Re: Site Plan

NAME OF PROPOSED DEVELOPMENT ROCKWALL COUNTY YMCA

SITE & GRADING PLAN
SCALE: 1" = 100'-0"

SITE PLAN REVIEW

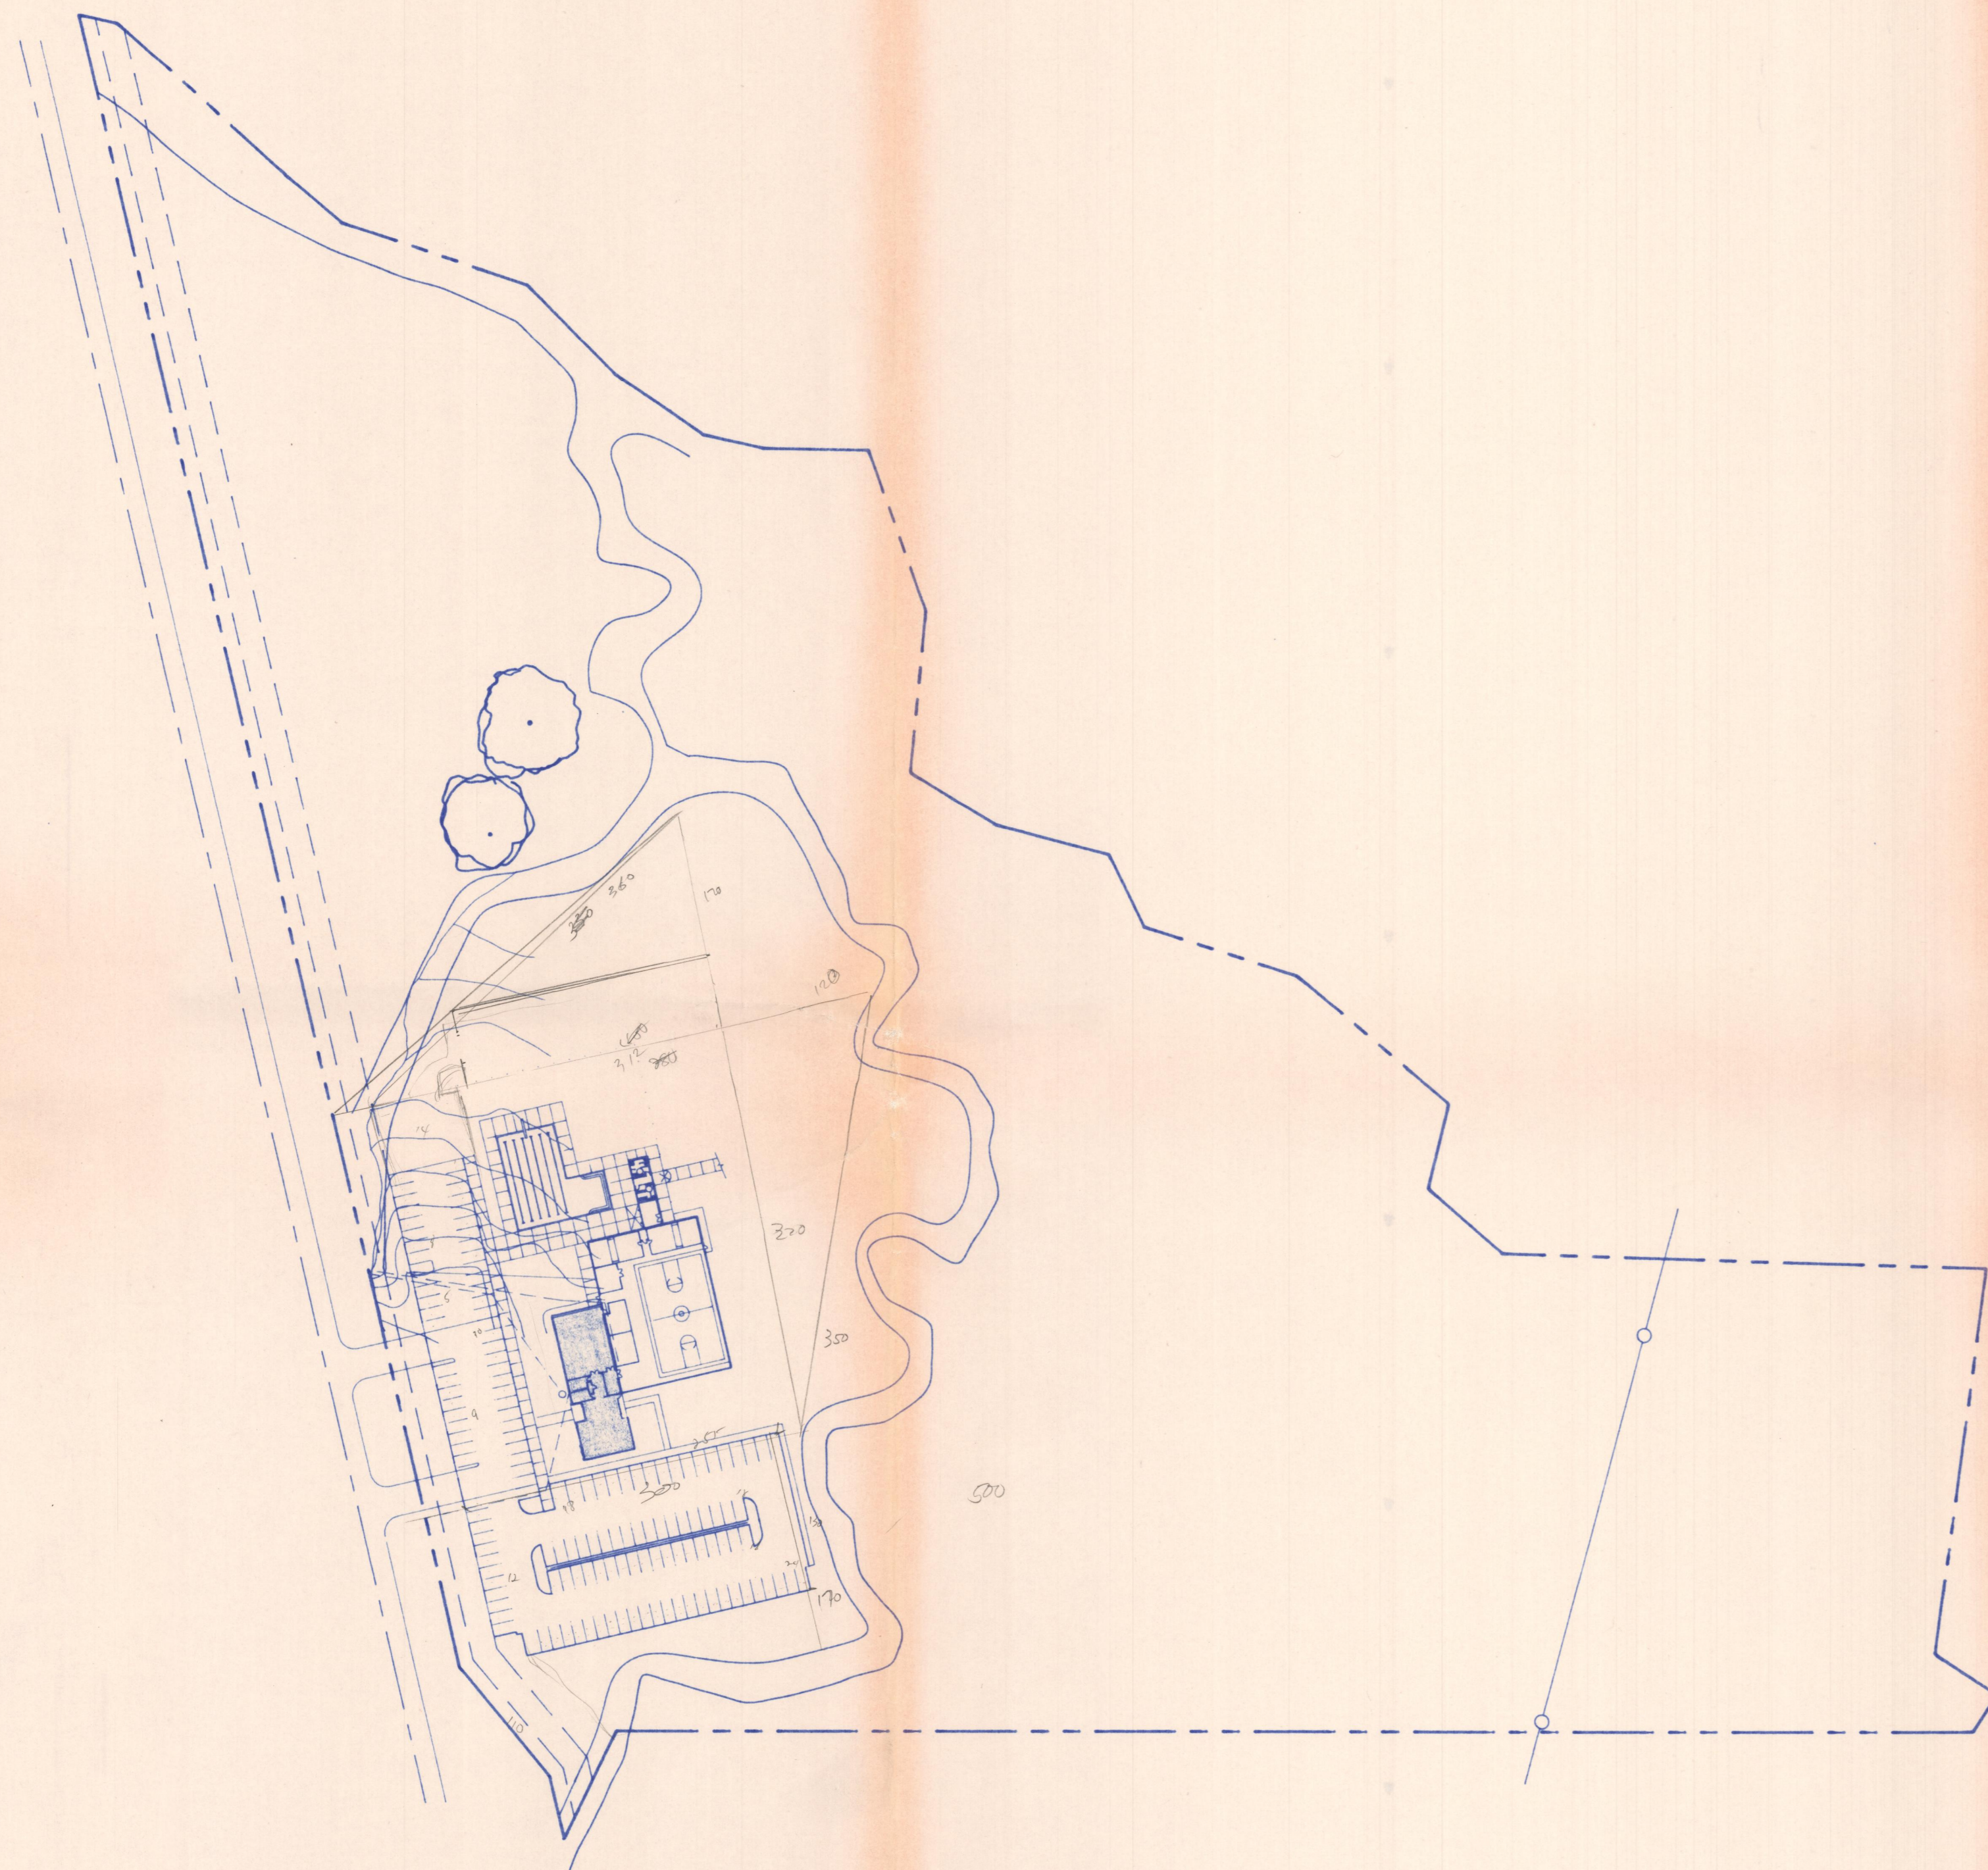
need to show on Plan

1. Height of Buildings

2. Additional 200¢ of landscaping in parking lot

3. ~~Proposed building materials~~ - need for curbside
Proposed heavy materials

4. 14 trees along front and 5 trees in parking lot.

5. Type of plantings

6. Screening around dumpster

7. Additional 60 parking spaces

8. How much parking is there? show detail as to what will be
Change provided parking to $142 + 60 = 202$

9. Where would relocated drive be ~~located~~ ^{located}

10. Change in fencing

11. Scale

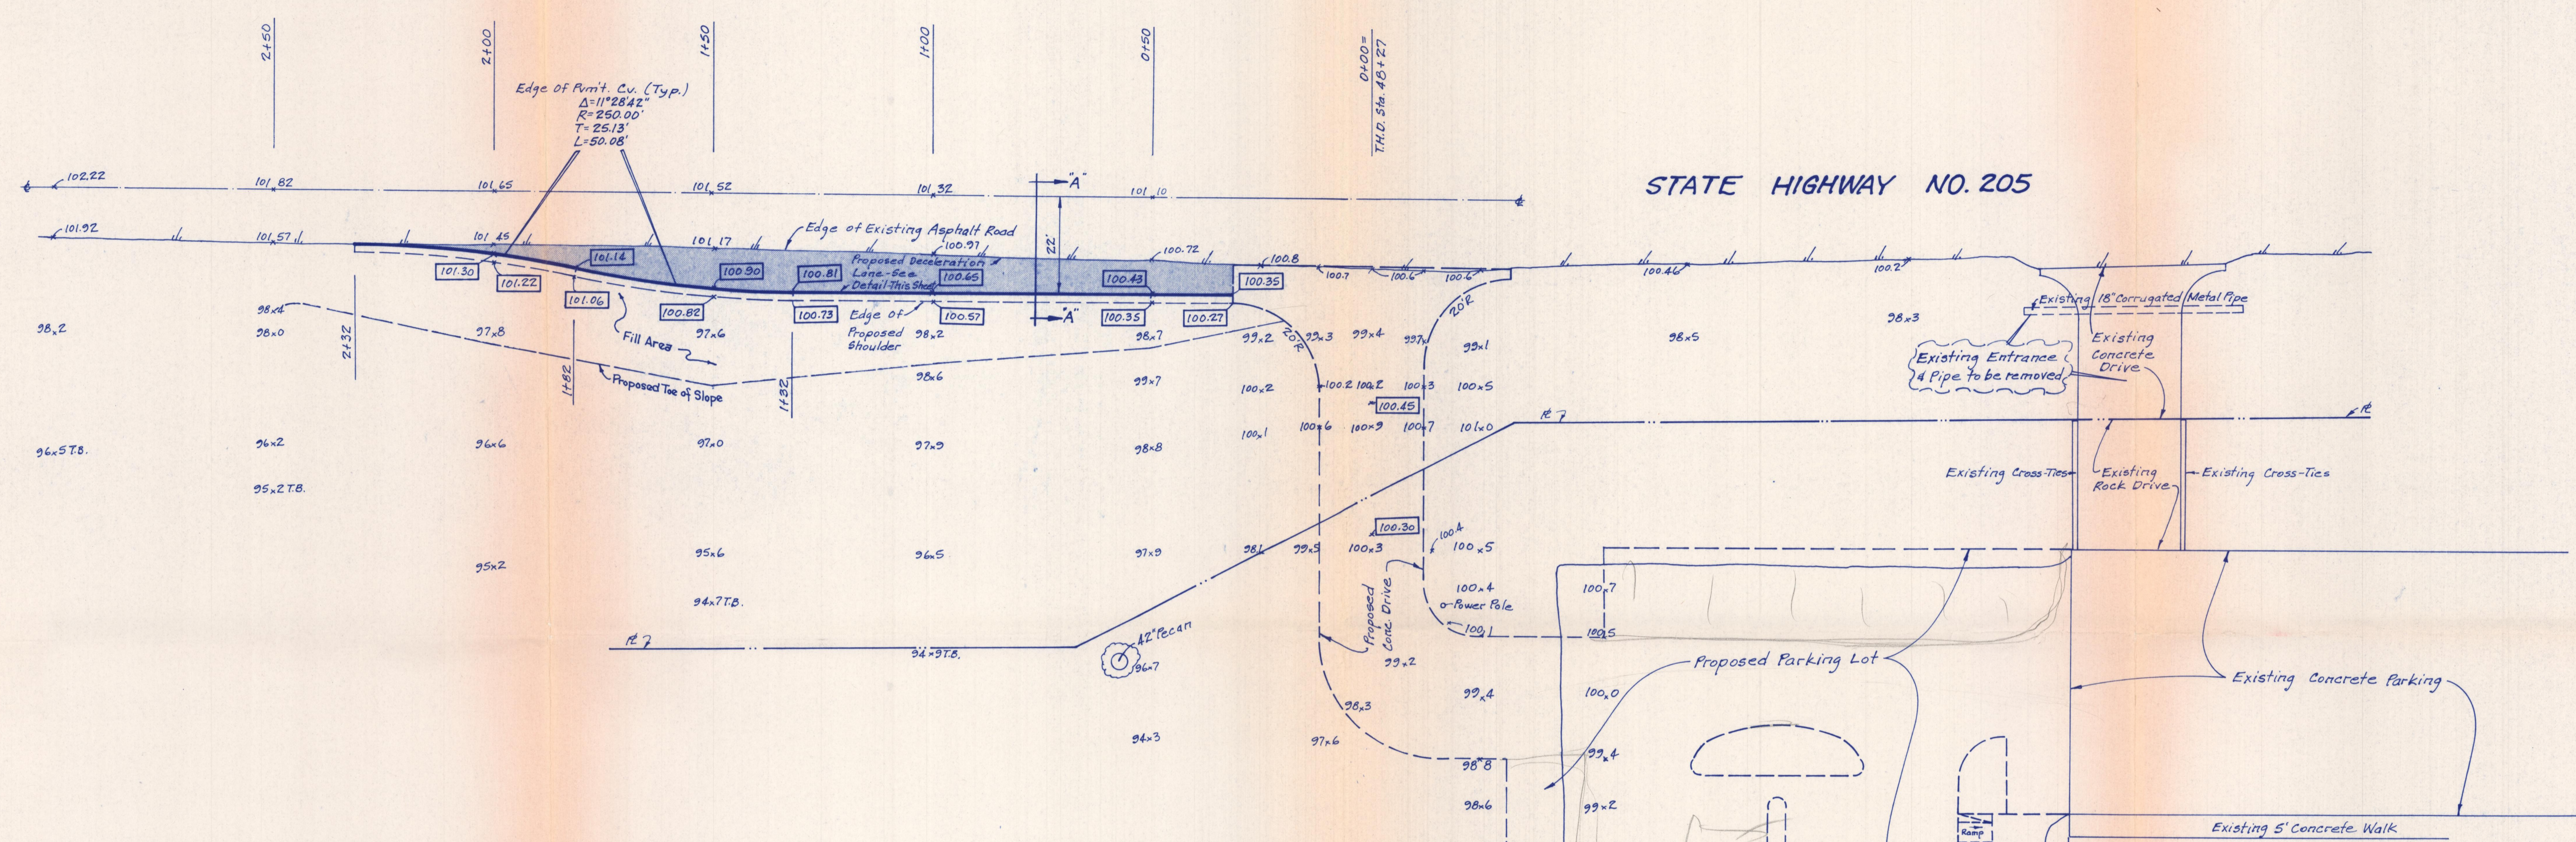
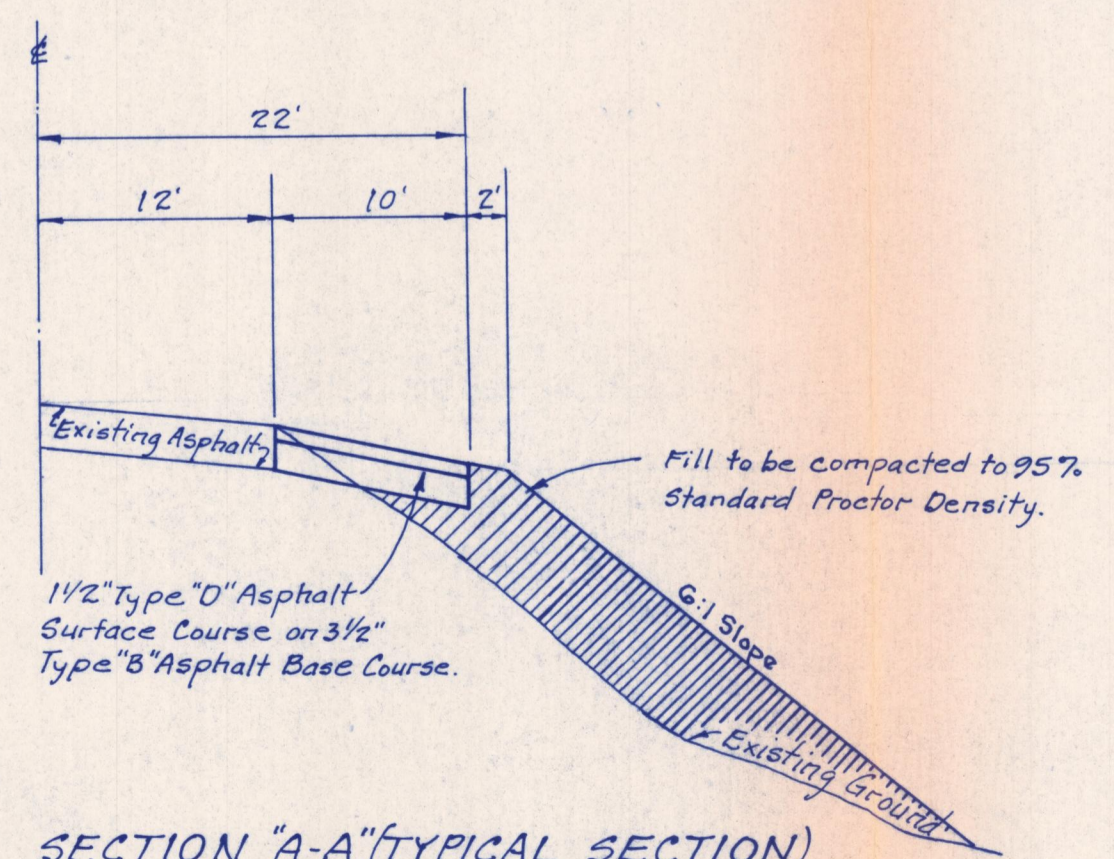
Please be advised, that the deceleration lane is approved based on the following condition; A 6:1 side slope is required for a minimum of 20 feet from the edge of shoulder. This condition meets Texas Department of Transportation clear zone requirements.
